# Woollahra Local Planning Panel (Public Meeting)

## **LOCAL PLANNING PANEL DEVELOPMENT APPLICATION ASSESSMENT REPORT**

顶级私宅  
12 The Crescent Vaucluse NSW 2030

*Height Plane Diagram (Source: Kannfinch)*

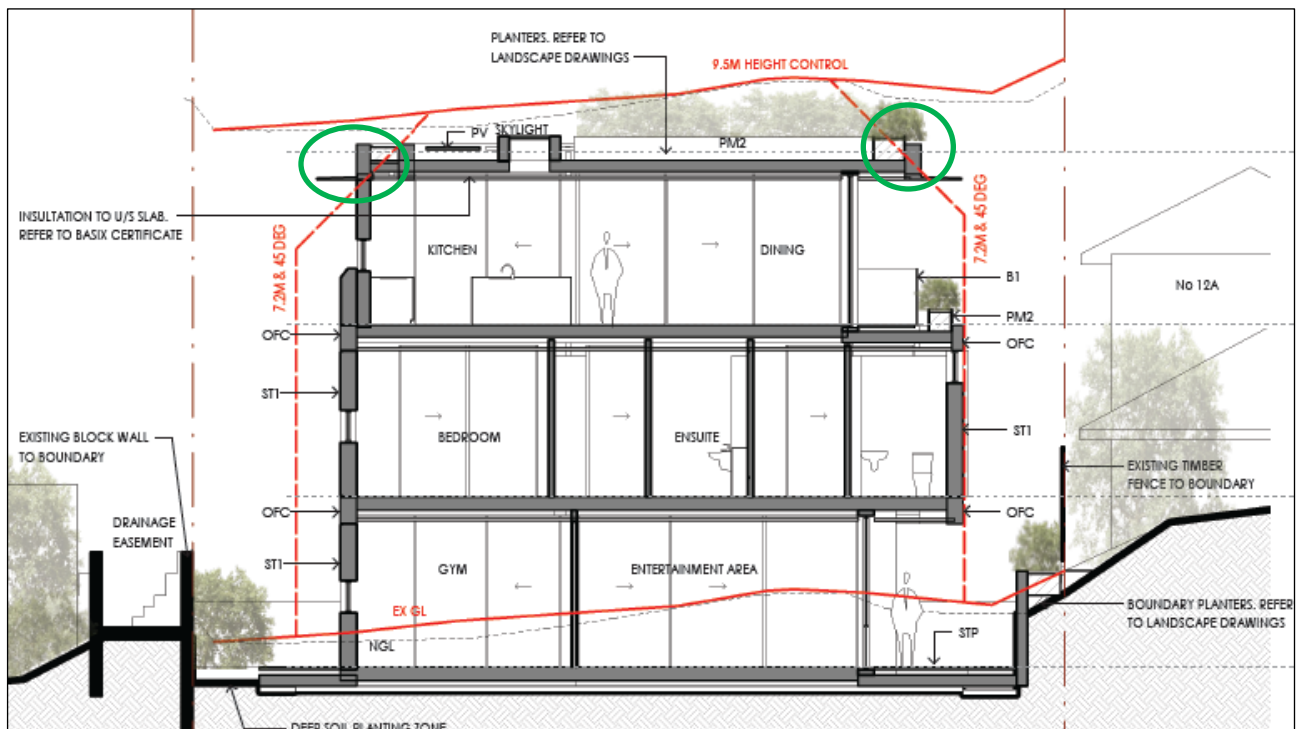
The proposal exhibits non-compliances with the southern side setback requirement, and with the wall height and inclined plan envelope controls.

Specifically, the garage is to be built up to the southern side boundary, with fixed timber battens forming the south-facing garage wall. Furthermore, elements of the upper portions of the dwelling will protrude from the building envelope set by the controls in Part B3.2 of the DCP and the 9.5m height limit as depicted in the height plane diagram below:

Excerpt from Section 02 (Source: Kannfinch)

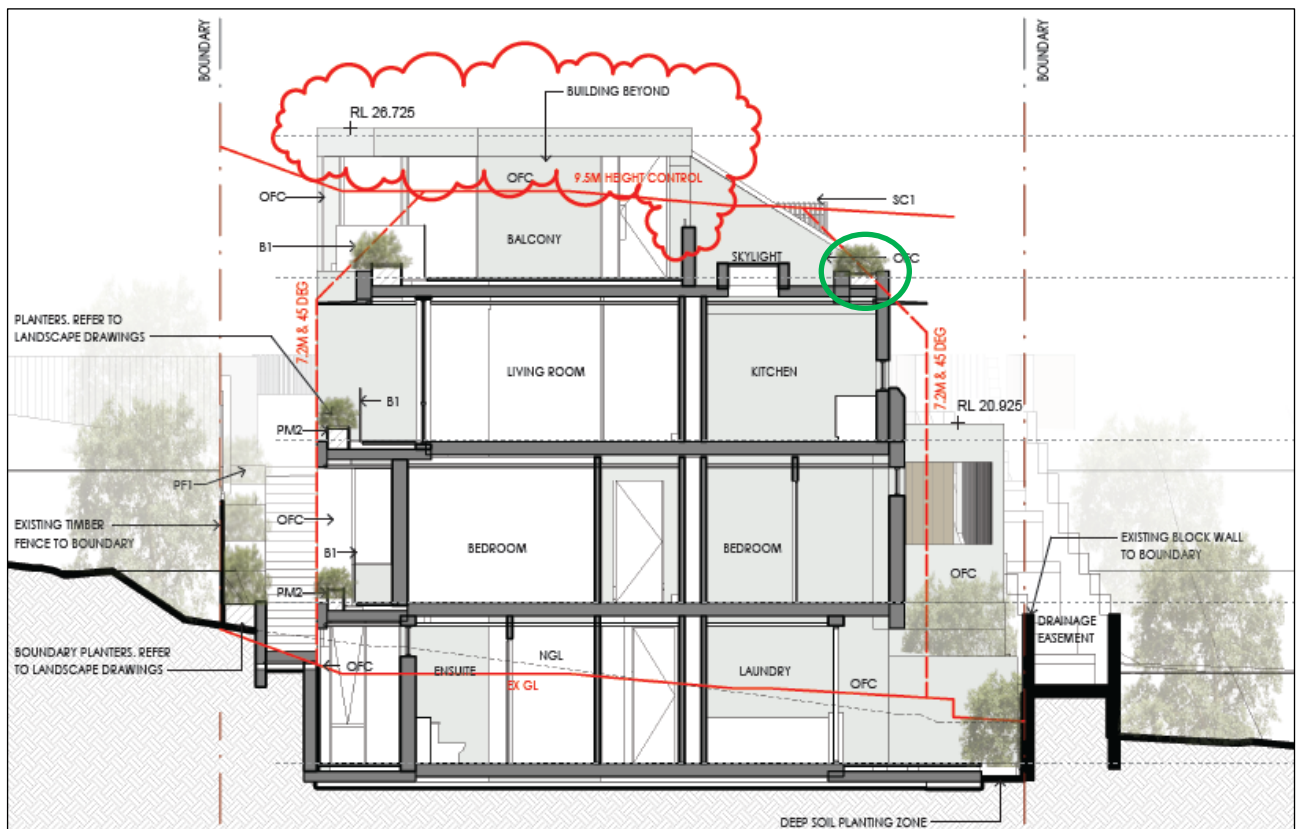
The Short Section drawings provided with the architectural plans also demonstrate the extent of the non-compliances with the building envelope controls at various points through the site, as circled in green. The images show that the extent of non-compliance with the building envelope controls is generally minor, with the exception of the garage structure.

#### *Ground Level*

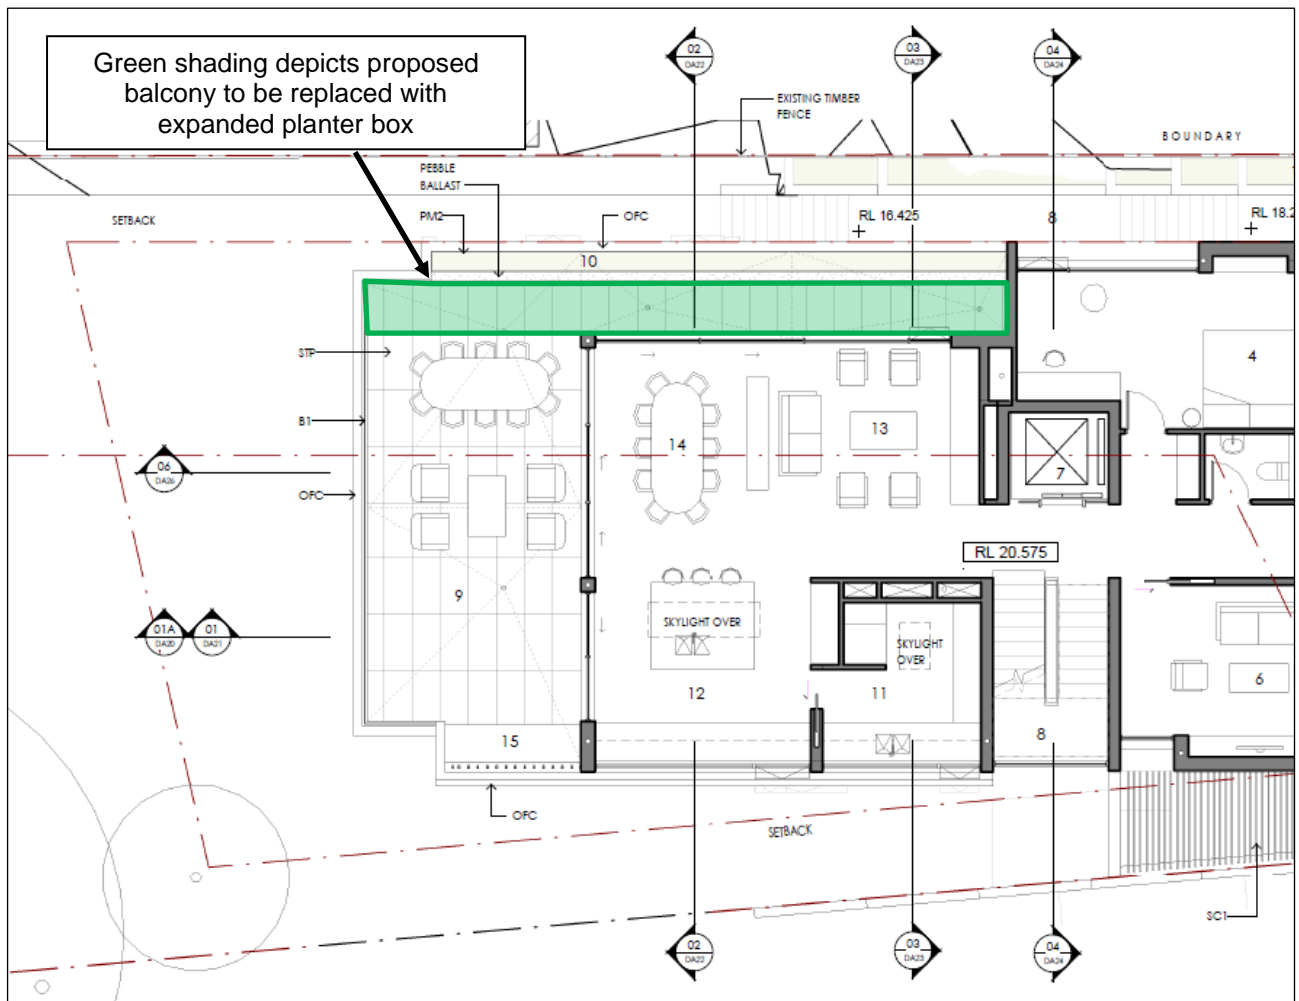
At the Ground Level, the proposed bedroom features a north-facing untreated window within close proximity of the front garden at no. 12A. The front garden is not the primary private open space area of 12A, but is the only substantially vegetated area of the site that can be used recreationally. As such, the untreated north-facing bedroom window at the ground floor level is required to incorporate external fixed timber batten screening to match the adjacent north-facing bedroom window. Refer to **Condition D.1 (e)**.

The northern living and dining area features large north-facing windows with an adjoining wraparound balcony that also faces toward the north and west of the site. The balcony in particular is considered to be excessive in size, and would allow for overlooking of the neighbouring property at no. 12A to an unacceptable degree. In this regard, **Condition D.1 (f)** is recommended requiring replacement of the trafficable portion of balcony along the northern side of the family and living area with an expanded planter box along the northern side of the level to a height of 1m above the finished floor level (i.e. to a minimum height of RL 21.575 AHD).

### Level 1

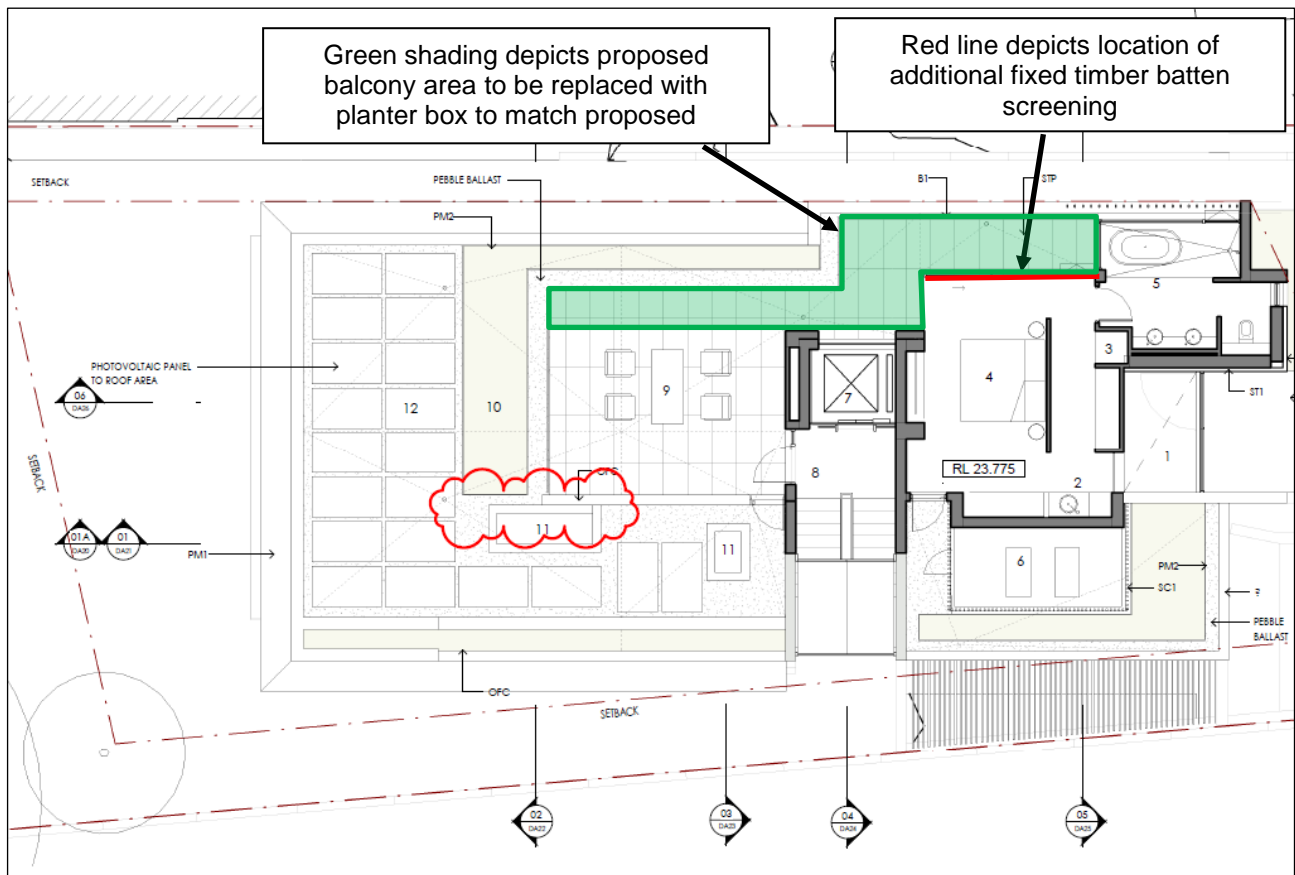
Level 1 of the new dwelling comprises of the master bedroom with ensuite at the front of the dwelling, and an adjoining roof terrace toward the rear.

In order to retain visual privacy to the front garden area of the northern adjoining property at 12A, two conditions have been imposed requiring the following modifications to the plans:

**c) Mid Level 'Lobby' balcony planter box height**

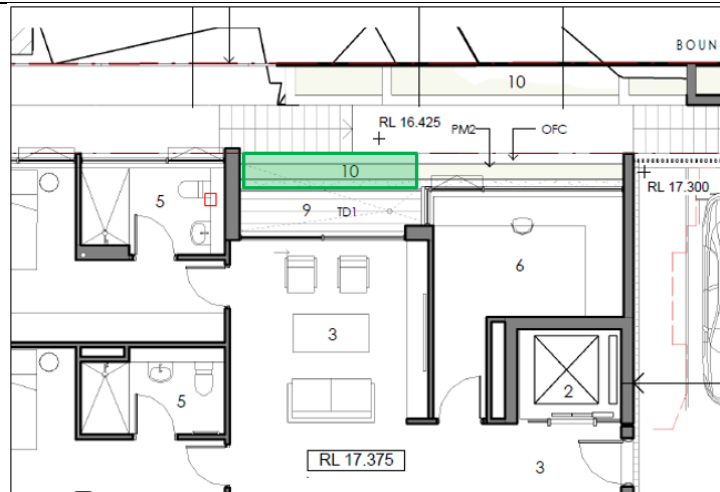
The planter box external to the Mid Level 'Lobby' balcony is required to have a minimum height of 1m above the finished floor level to prevent overlooking from within the lobby area toward the front private open space area of 12A The Crescent. The location of the planter to be raised is within the green box in the image below:

**d) Deletion of rear-facing Mid Level balcony**

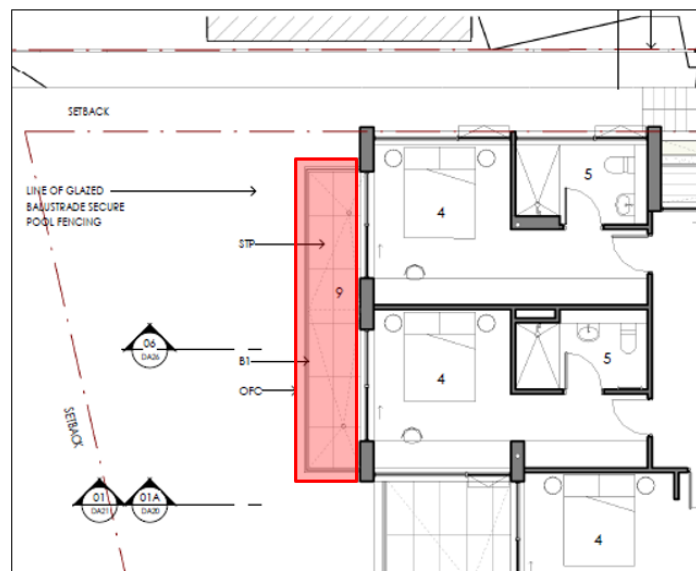
The rear-facing Mid Level balcony that adjoins the two rear-facing bedrooms is to be deleted from the plans to prevent overlooking towards the south-facing habitable room windows of the dwelling at 12A The Crescent, as depicted in red in the image below:

**h) Portion of trafficable Level 1 terrace to be non-trafficable**

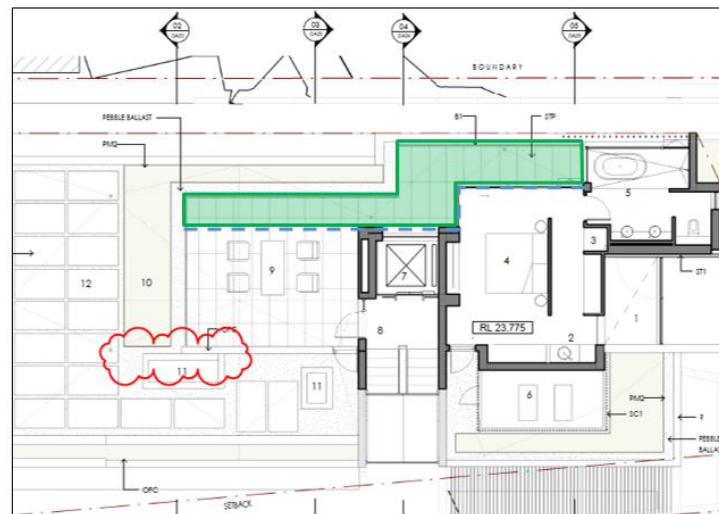
The northern portions of the Level 1 terrace are to be converted to a non-trafficable low planter to match the proposed Level 1 planter, as represented by a number '10' on the Level 1 Plan. The area to be converted is depicted in green in the image below, with the location of the relocated balustrade shown dashed in blue:
